Item Name: Strut Assembly

ENGINEERING CHANGE NOTICE NO.

DWG NO. 647.7700

DWG TITLE: STRUT ASSY

05397

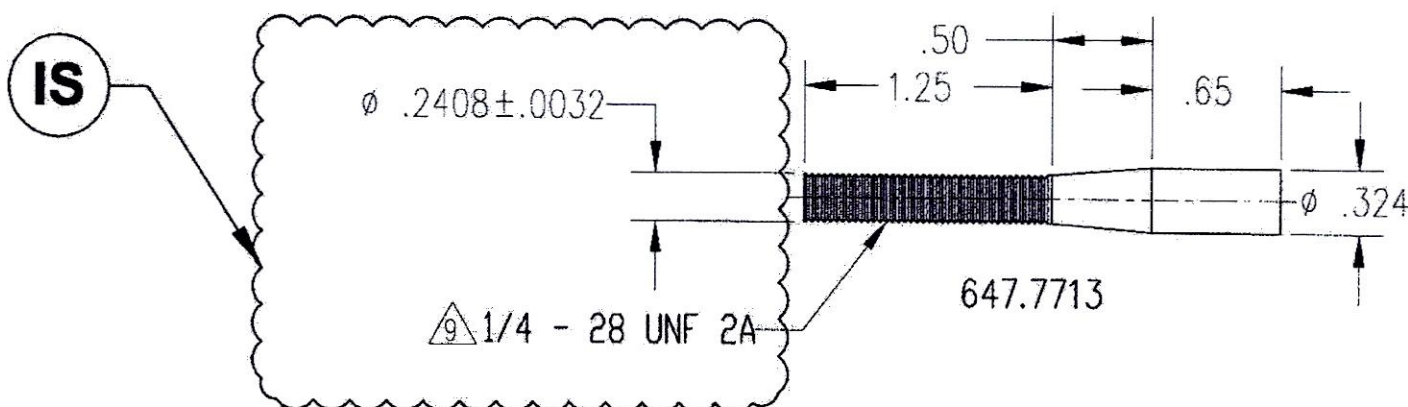
REASON: REVISED DIMENSION

SHEET 2, ZONE D4 IS:

SHEET 1 OF 2
SCALE NONE
REV. A
DATE 07/26/16
DWG. NO. 647.7700

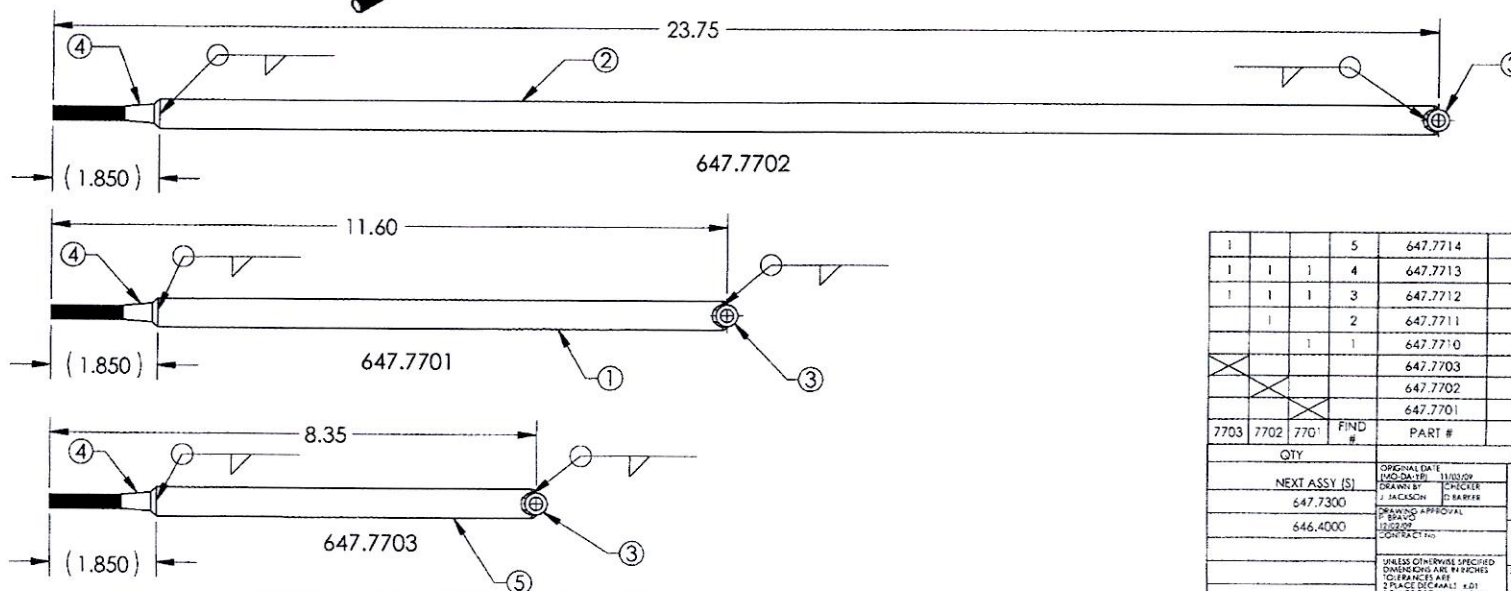
REASON: REVISED FINISH CALLOUT AS PER ECR 15-209

SHEET 1, NOTES IS:

- 1 MATERIAL: 4130 STEEL PER AMS-T-6736, .50" OD, .083" WALL THK.
- 2 MATERIAL: 4130 STEEL PER AMS-T-6736, .375" OD, .075" WALL THK.
- 3 MATERIAL: 4130 STEEL PER AMS-T-6736, .324" OD.
- 4 FINISH: PRIME IAW MIL-P-2337J TYPE I CLASS N; 1-2 MIL MAX
5. DEBURR AND BREAK ALL SHARP EDGES
6. IDENTIFY IAW MPP-120.
- 7 WELD IAW MIL-STD-2219. TIG WELD WITH FILLER ROD
- 8 FINISH: CAD PLATE IAW QQ-P-416F CLASS I TYPE II
- 9 MASK THREAD PRIOR TO FINISH
